**PLANNING BOARD  
PORTSMOUTH, NEW HAMPSHIRE**

**May 16, 2024**

**AGENDA**

SITE PLAN C3

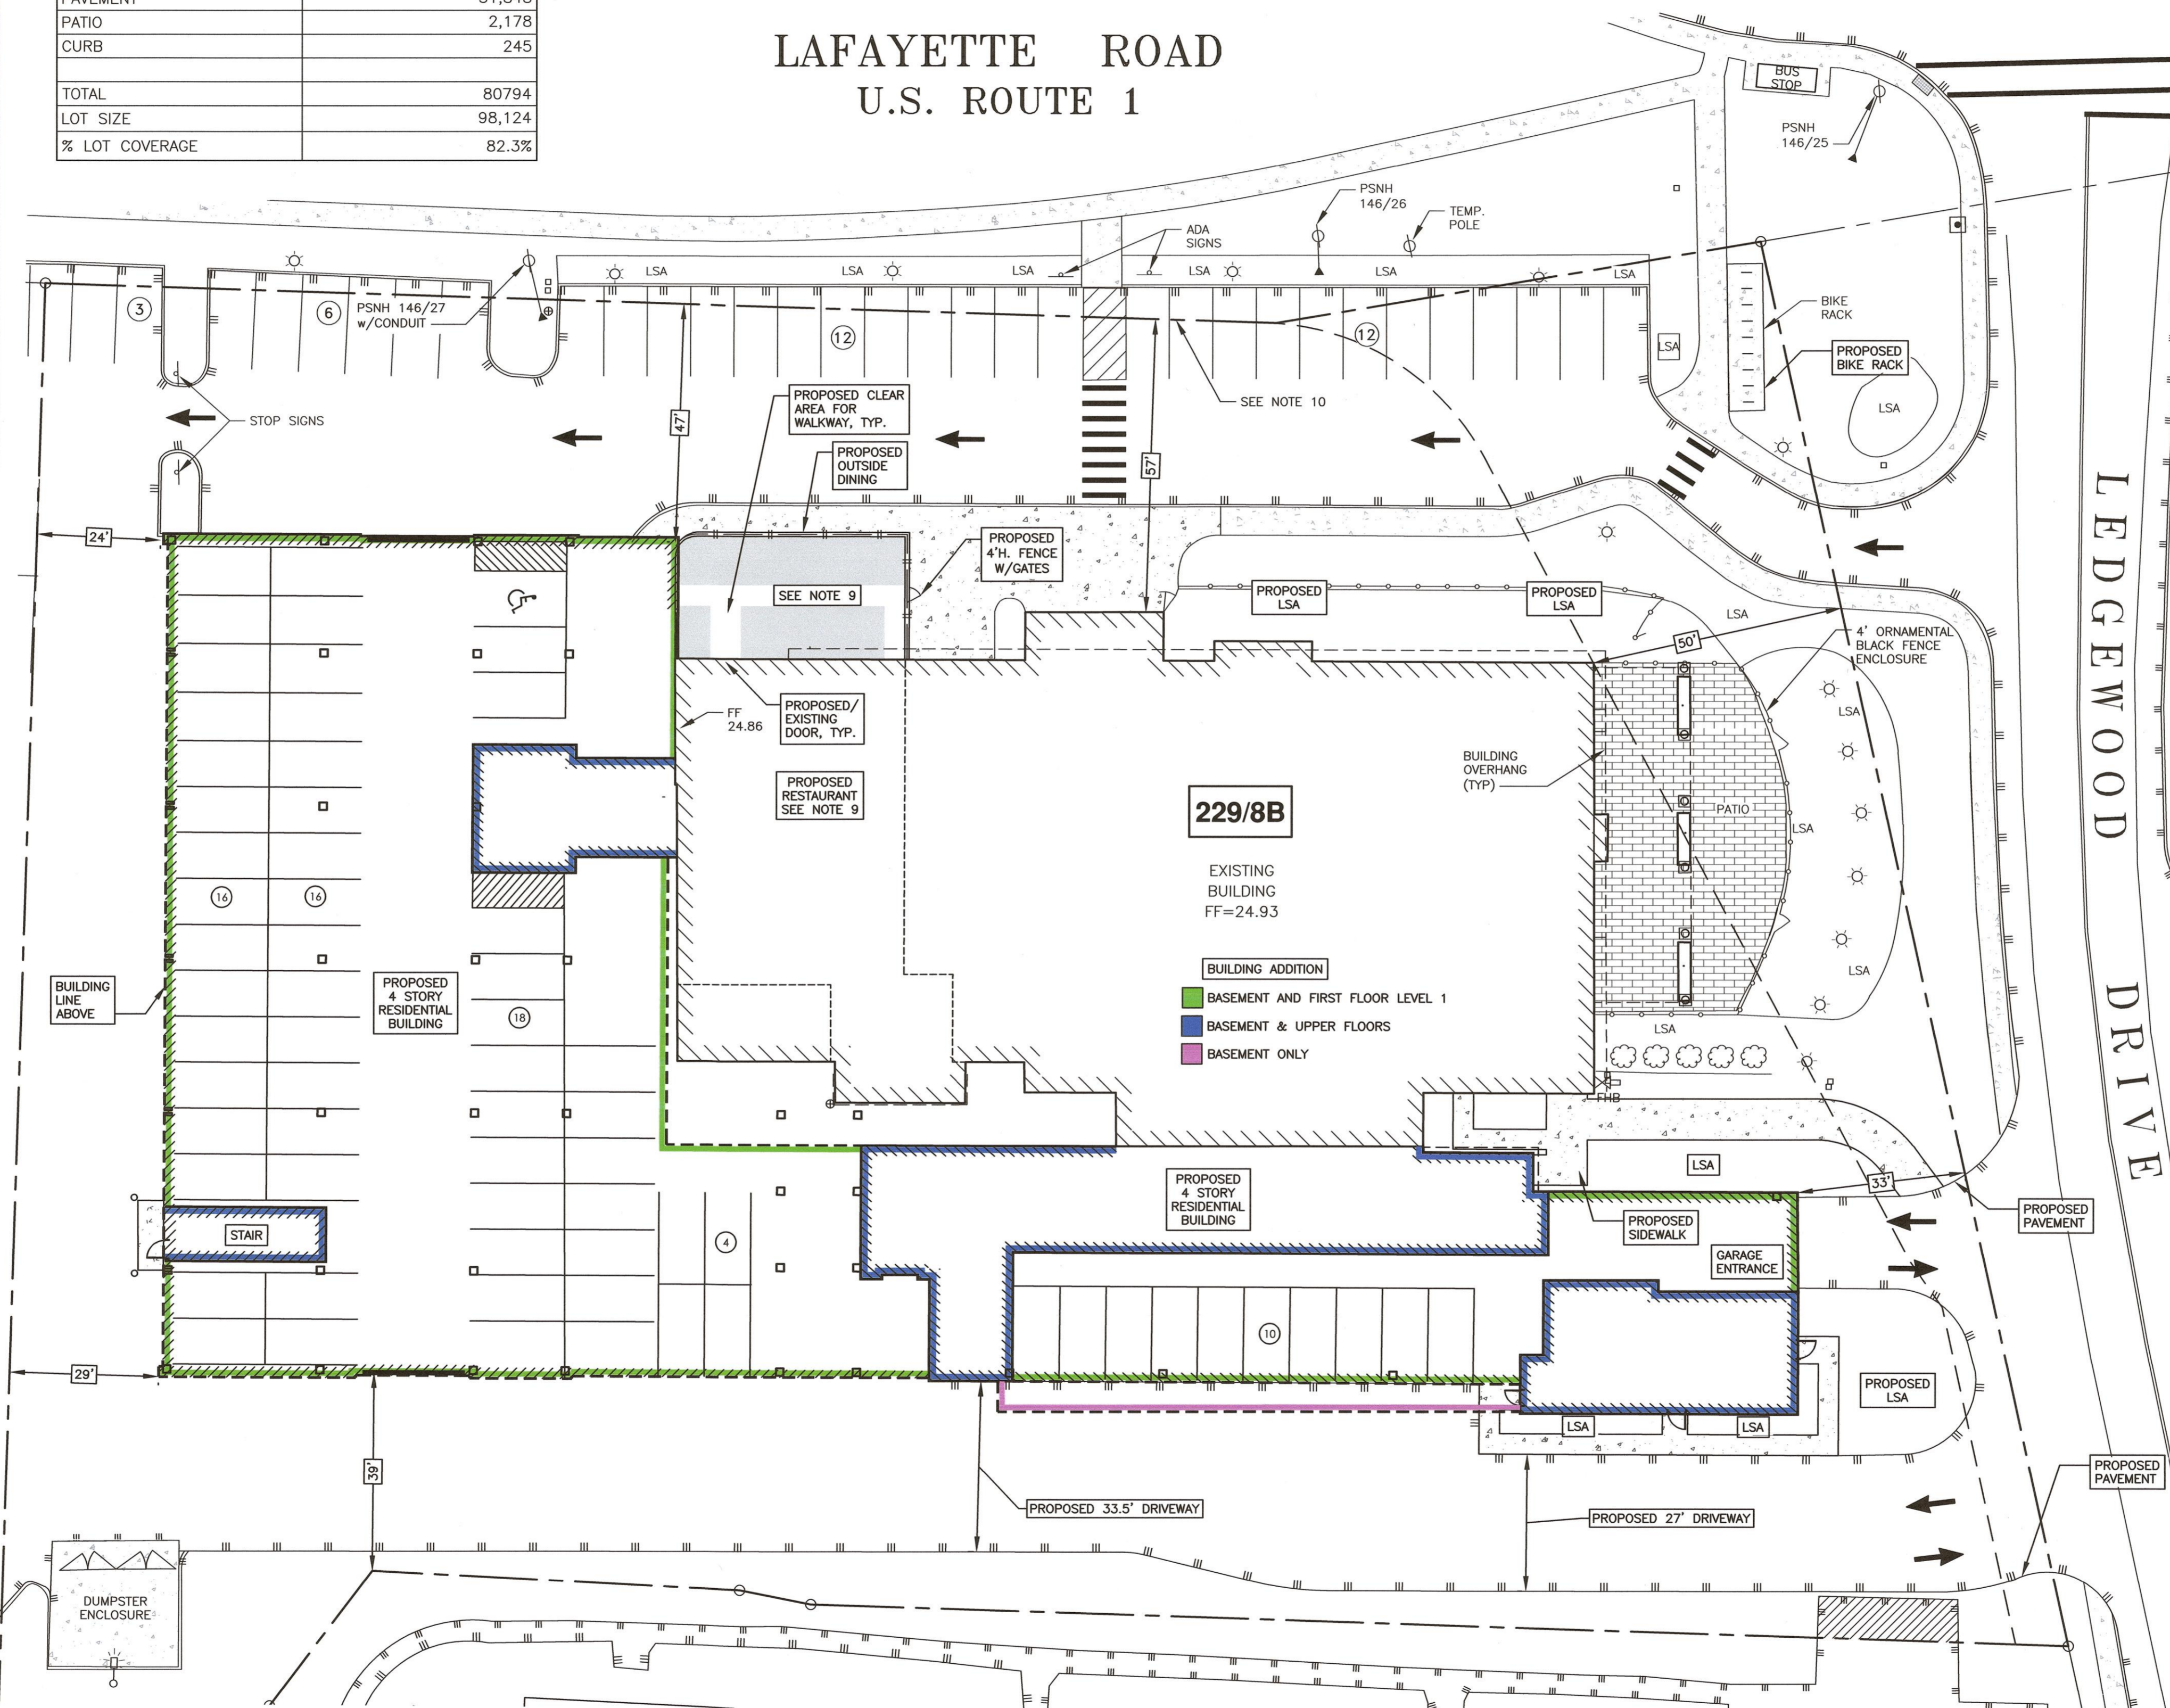
10. Please assign tandem parking spaces to units and confirm they conform to Section 10.1114.33. **The tandem spaces will be assigned to the units during the final building permit plan process. In the meantime, we added Note 10 on Sheet C3 and Note 5 on Sheet C4 to delineate this requirement.**
